Technical Update

Issue Number: TU228

Product Description: **SmartPilot S1 & S1G Course Computers, Corepacks & Systems**

Subject: **Fluxgate Compass Circuit Fault**

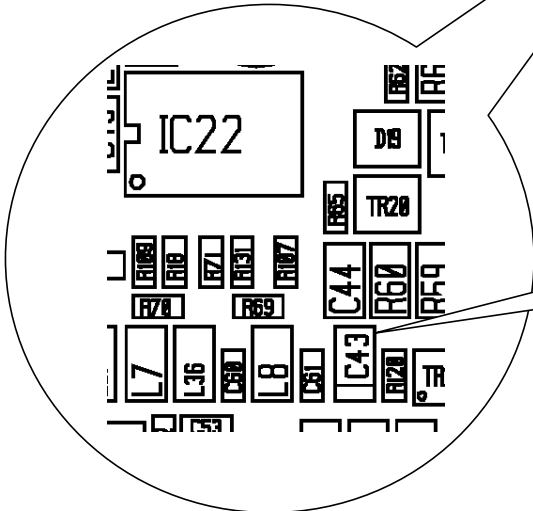
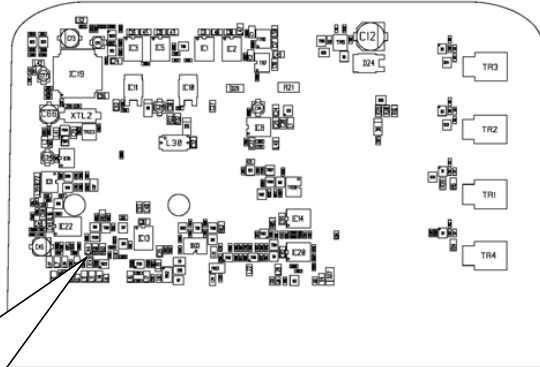
The fault is associated with the wrongly reverse placement of the fluxgate drive AC coupling capacitor C43. The fault does not affect all S1 Course Computers and is only triggered when the tolerance of the capacitor is at the limits of its value specification.

- Follow procedure over.
- Remove PCB from Course Computer Case
- Locate C43 Capacitor
- Unsolder & remove from PCB
- Replace and re-solder in reverse (see diagrams)
- Replace PCB into case
- 15mins labour per unit can be claimed against warranty
- For onboard service follow the normal warranty claims procedure

Service Details and Procedures

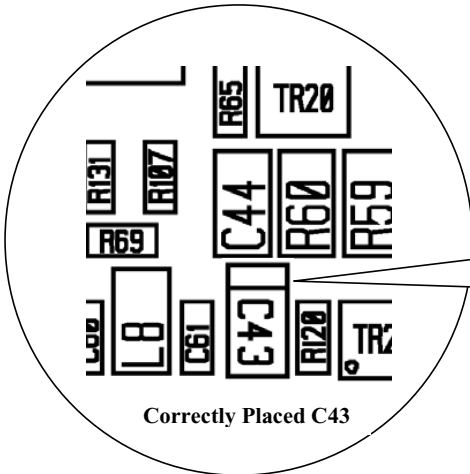
C43 Polarised Capacitor 2.2uF 6.3v
Wrongly Placed on PCB!

Correctly Placed C43

- Remove PCB from plastic casing
- Locate C43 Capacitor
- Unsolder & Remove from PCB
- Replace & re-solder in reverse
